WCHS Track and Field: Change Order #04 Summary

| DATE: | 10/17/2024 | PR #: | PR 006 |
| TO: | Clay Ratliff – Trace Creek Construction | RE: | Woodford County Board of Education Versailles, Kentucky BG 19-353 RTA 1916 Phase 2 |

SA4.3

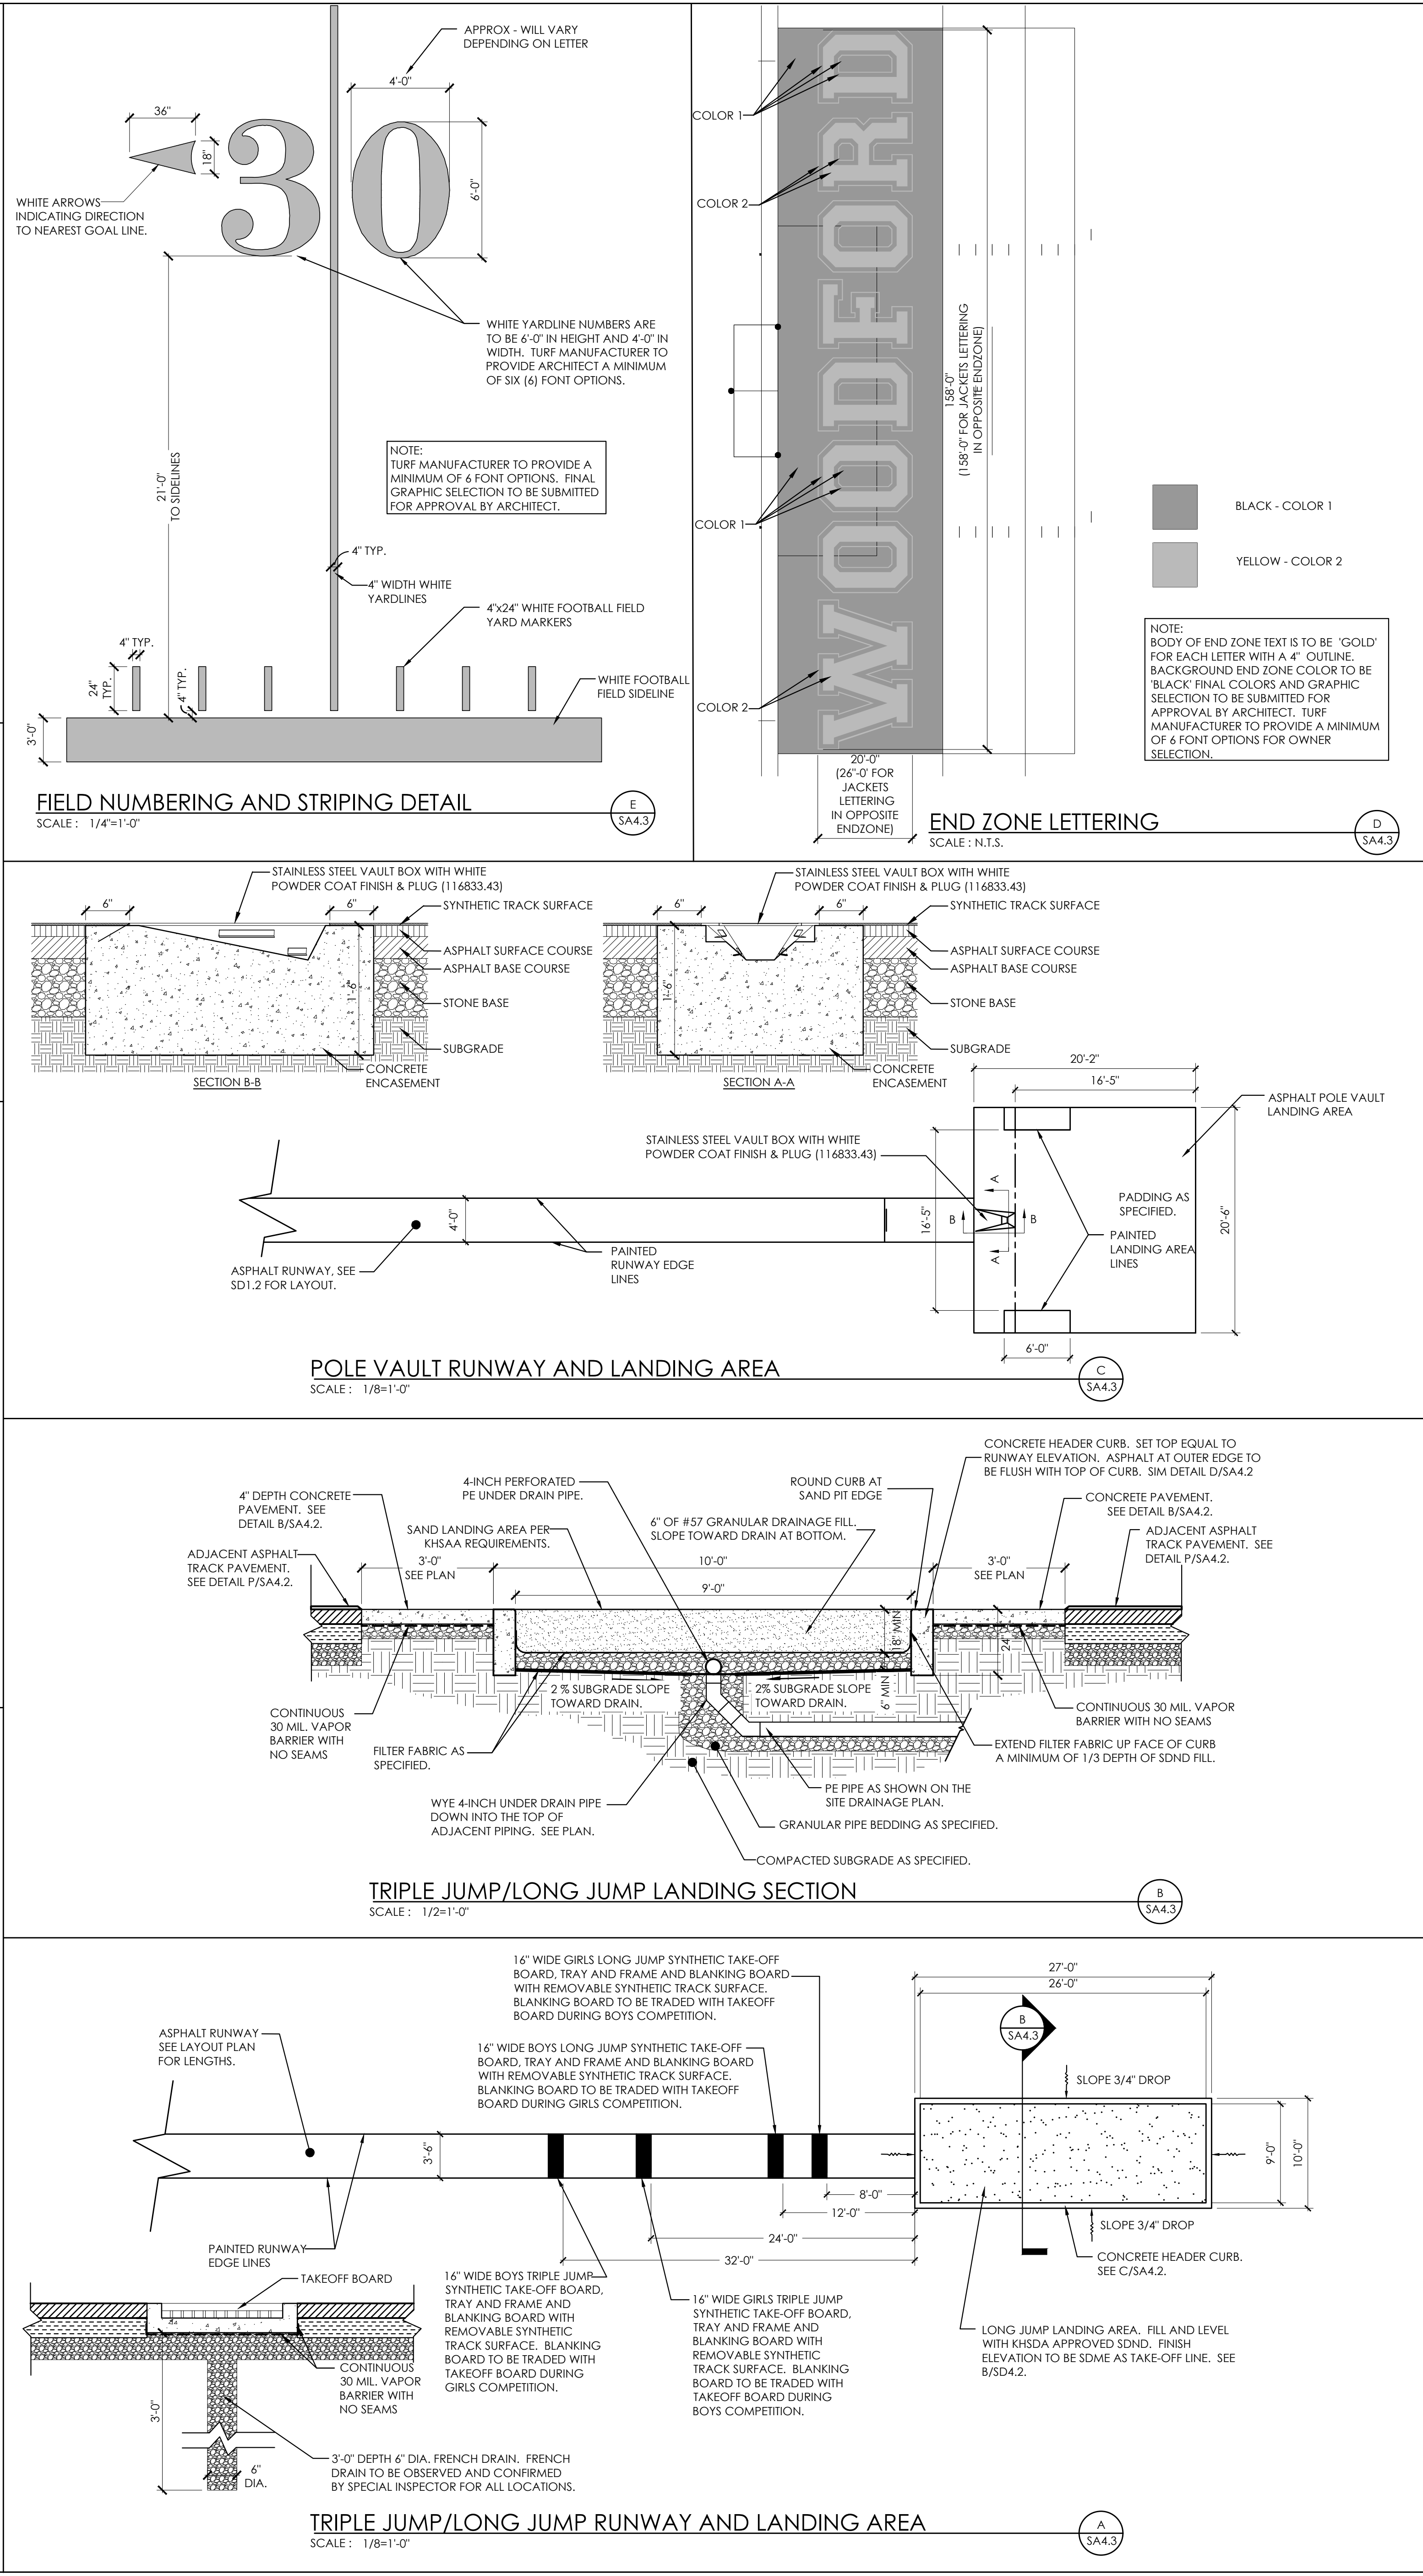
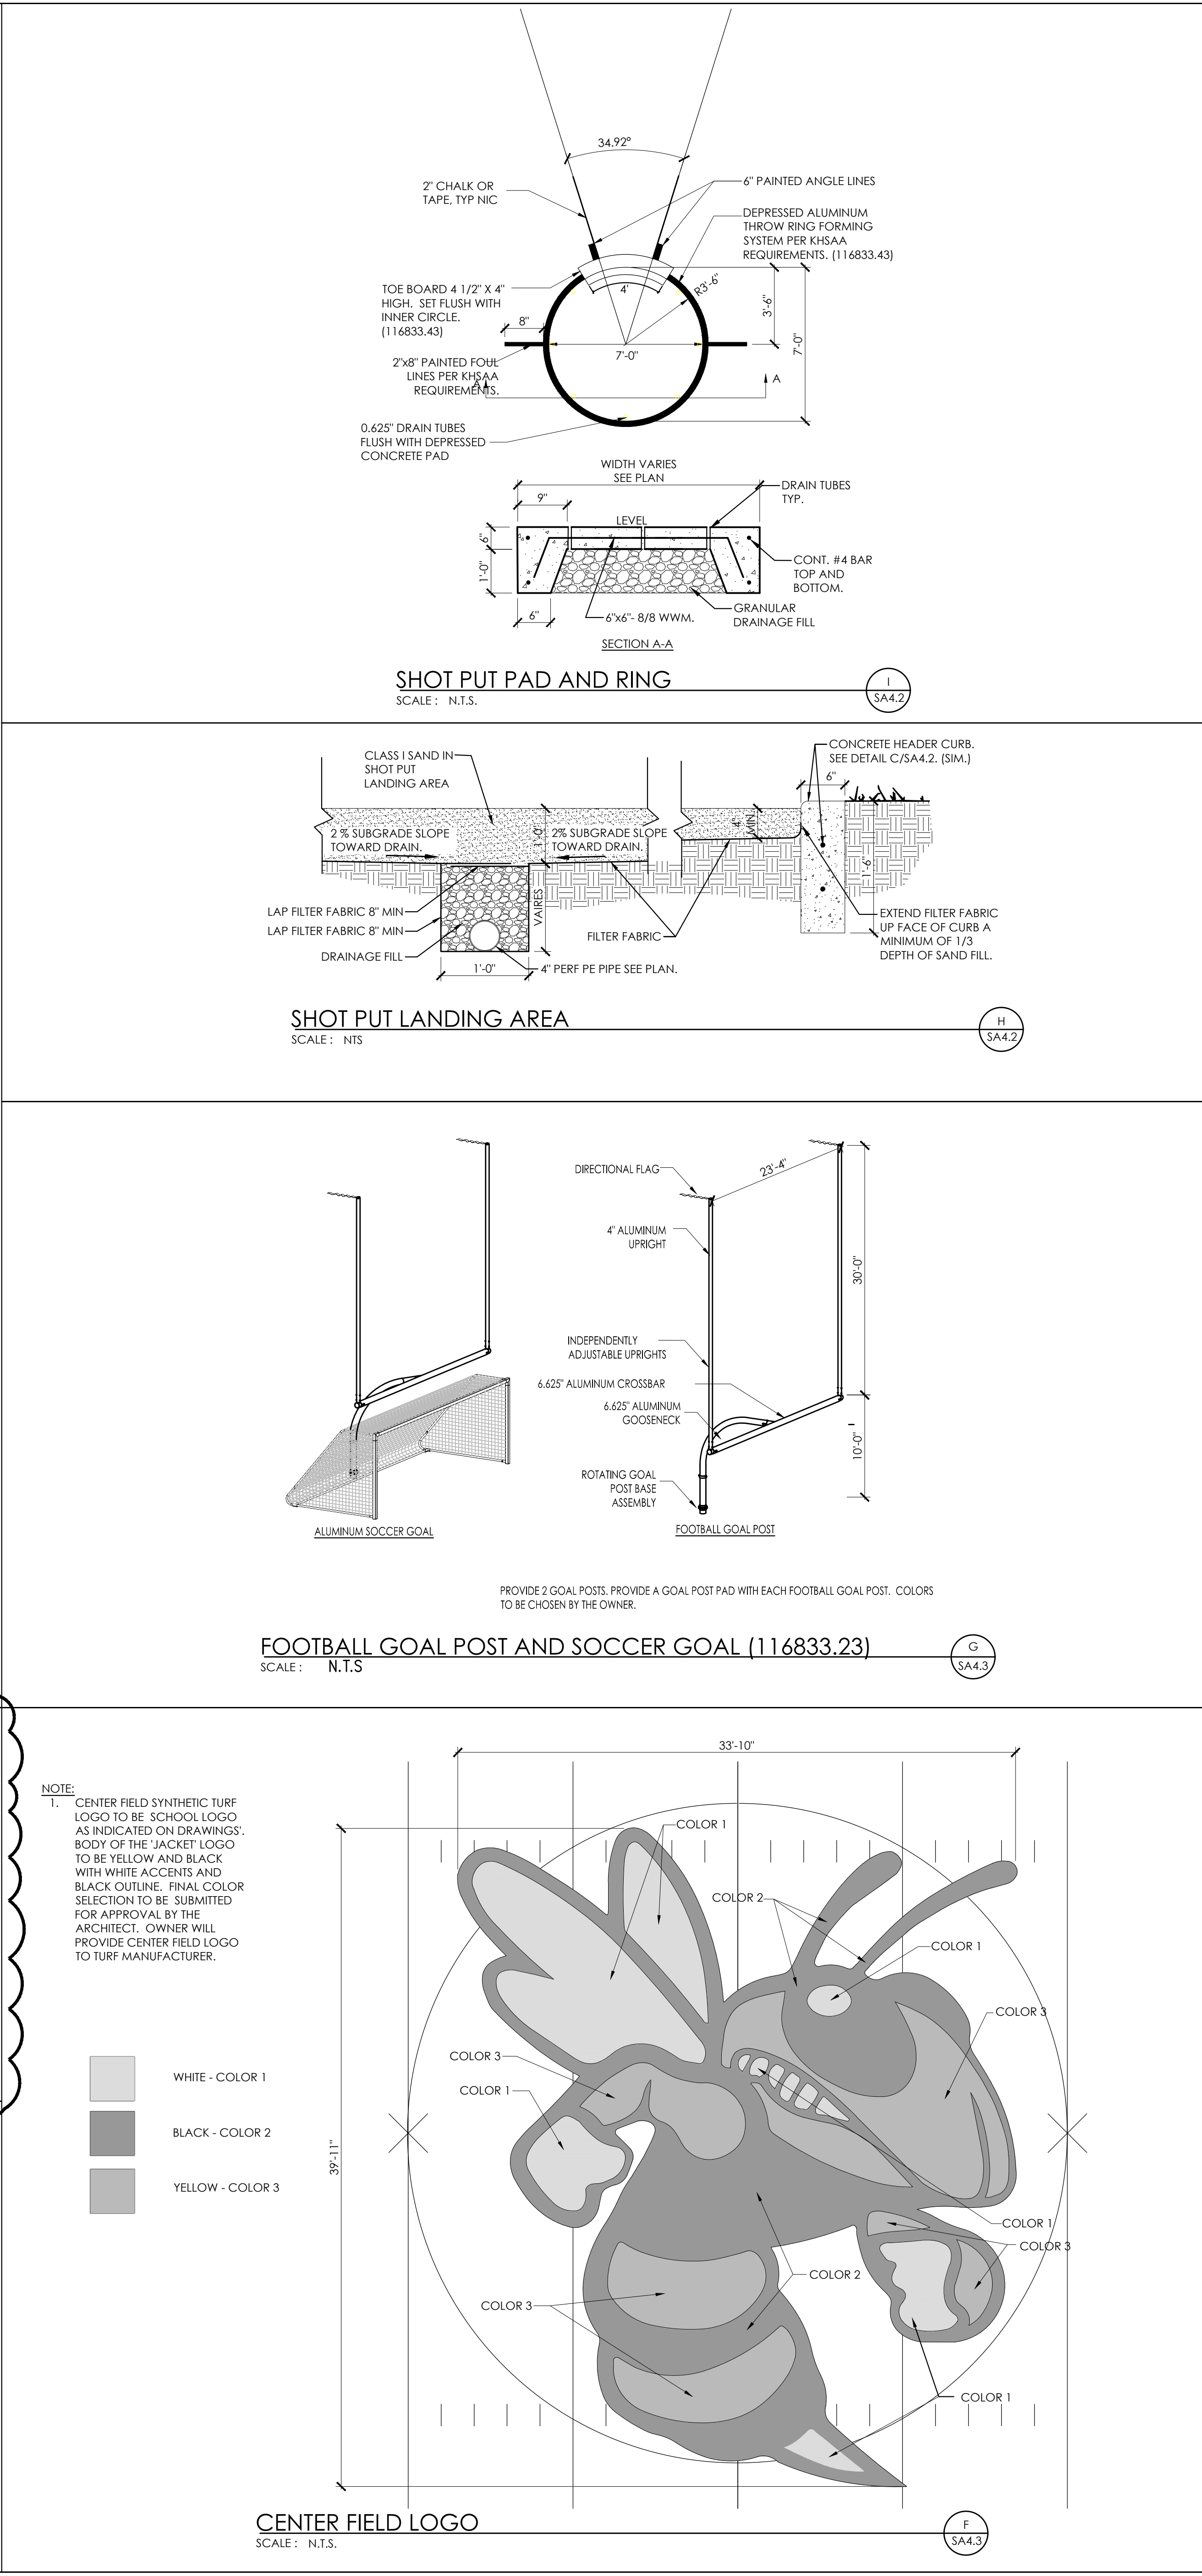
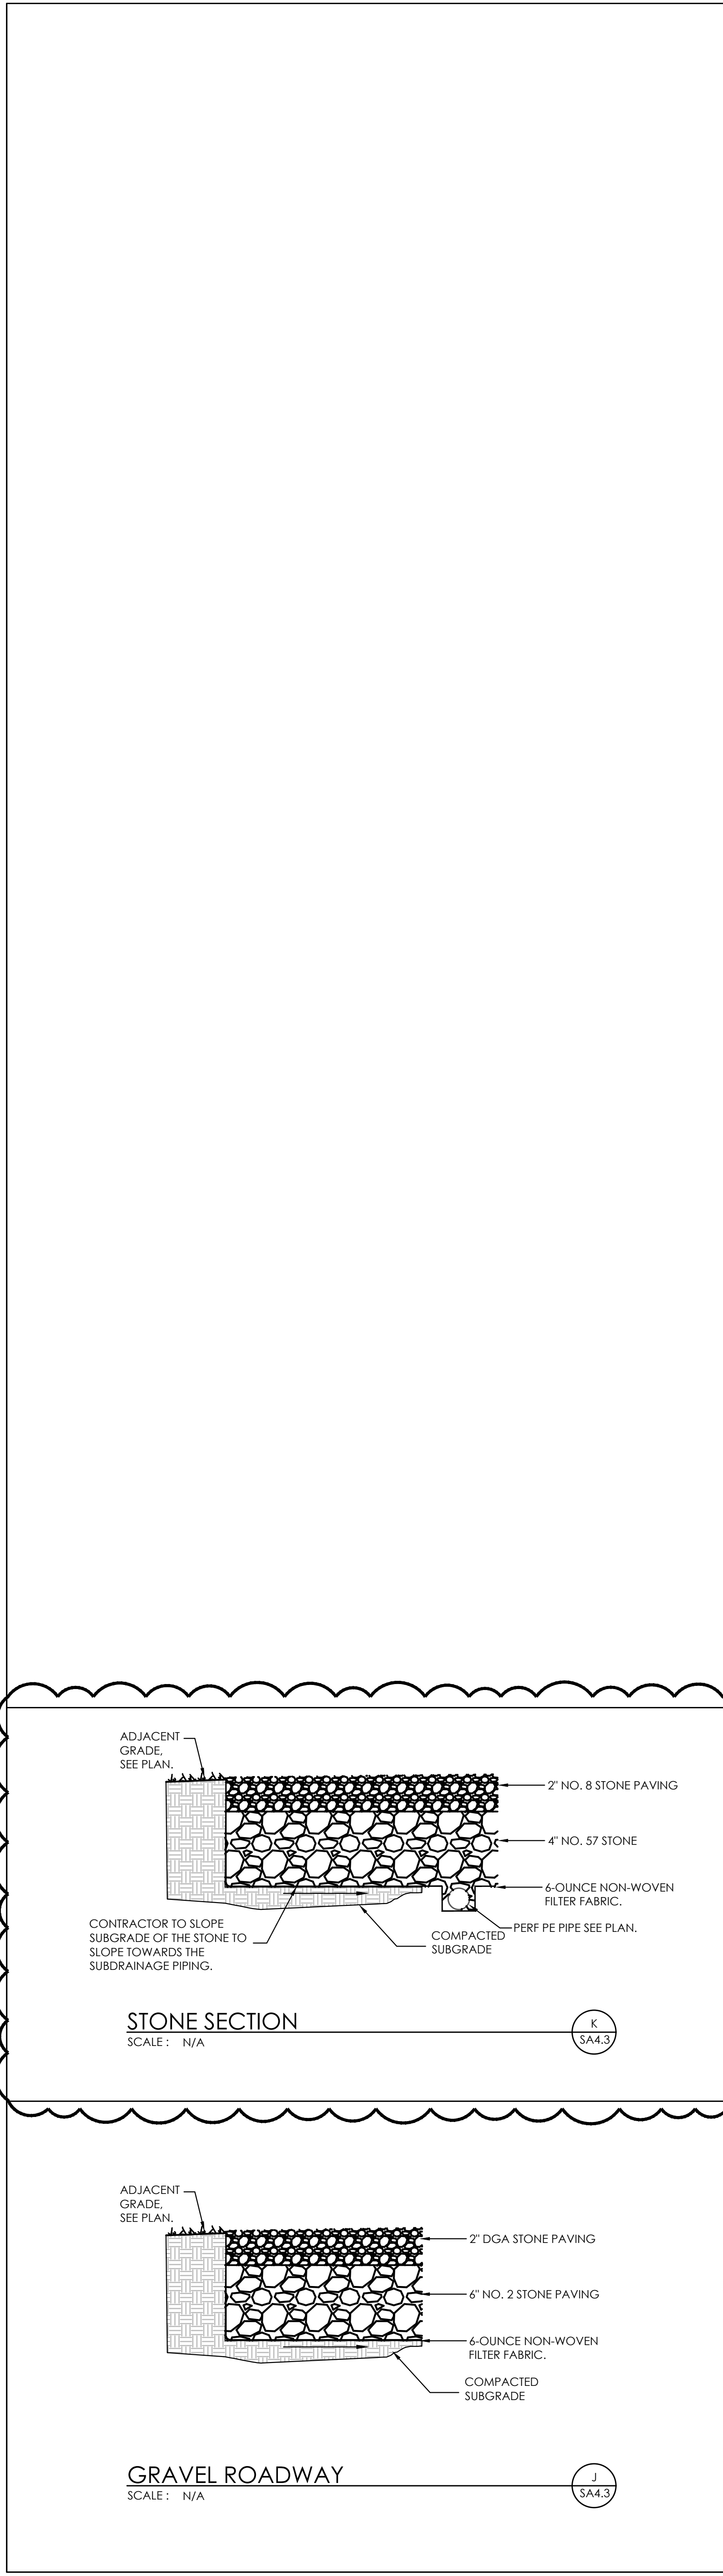
5. Refer to SA4.3:
 - a) Add stone section detail as shown.
6. Refer to the revised site utility drawings UE2.1:
 - a) Add infrastructure to support pressbox and videoboard.
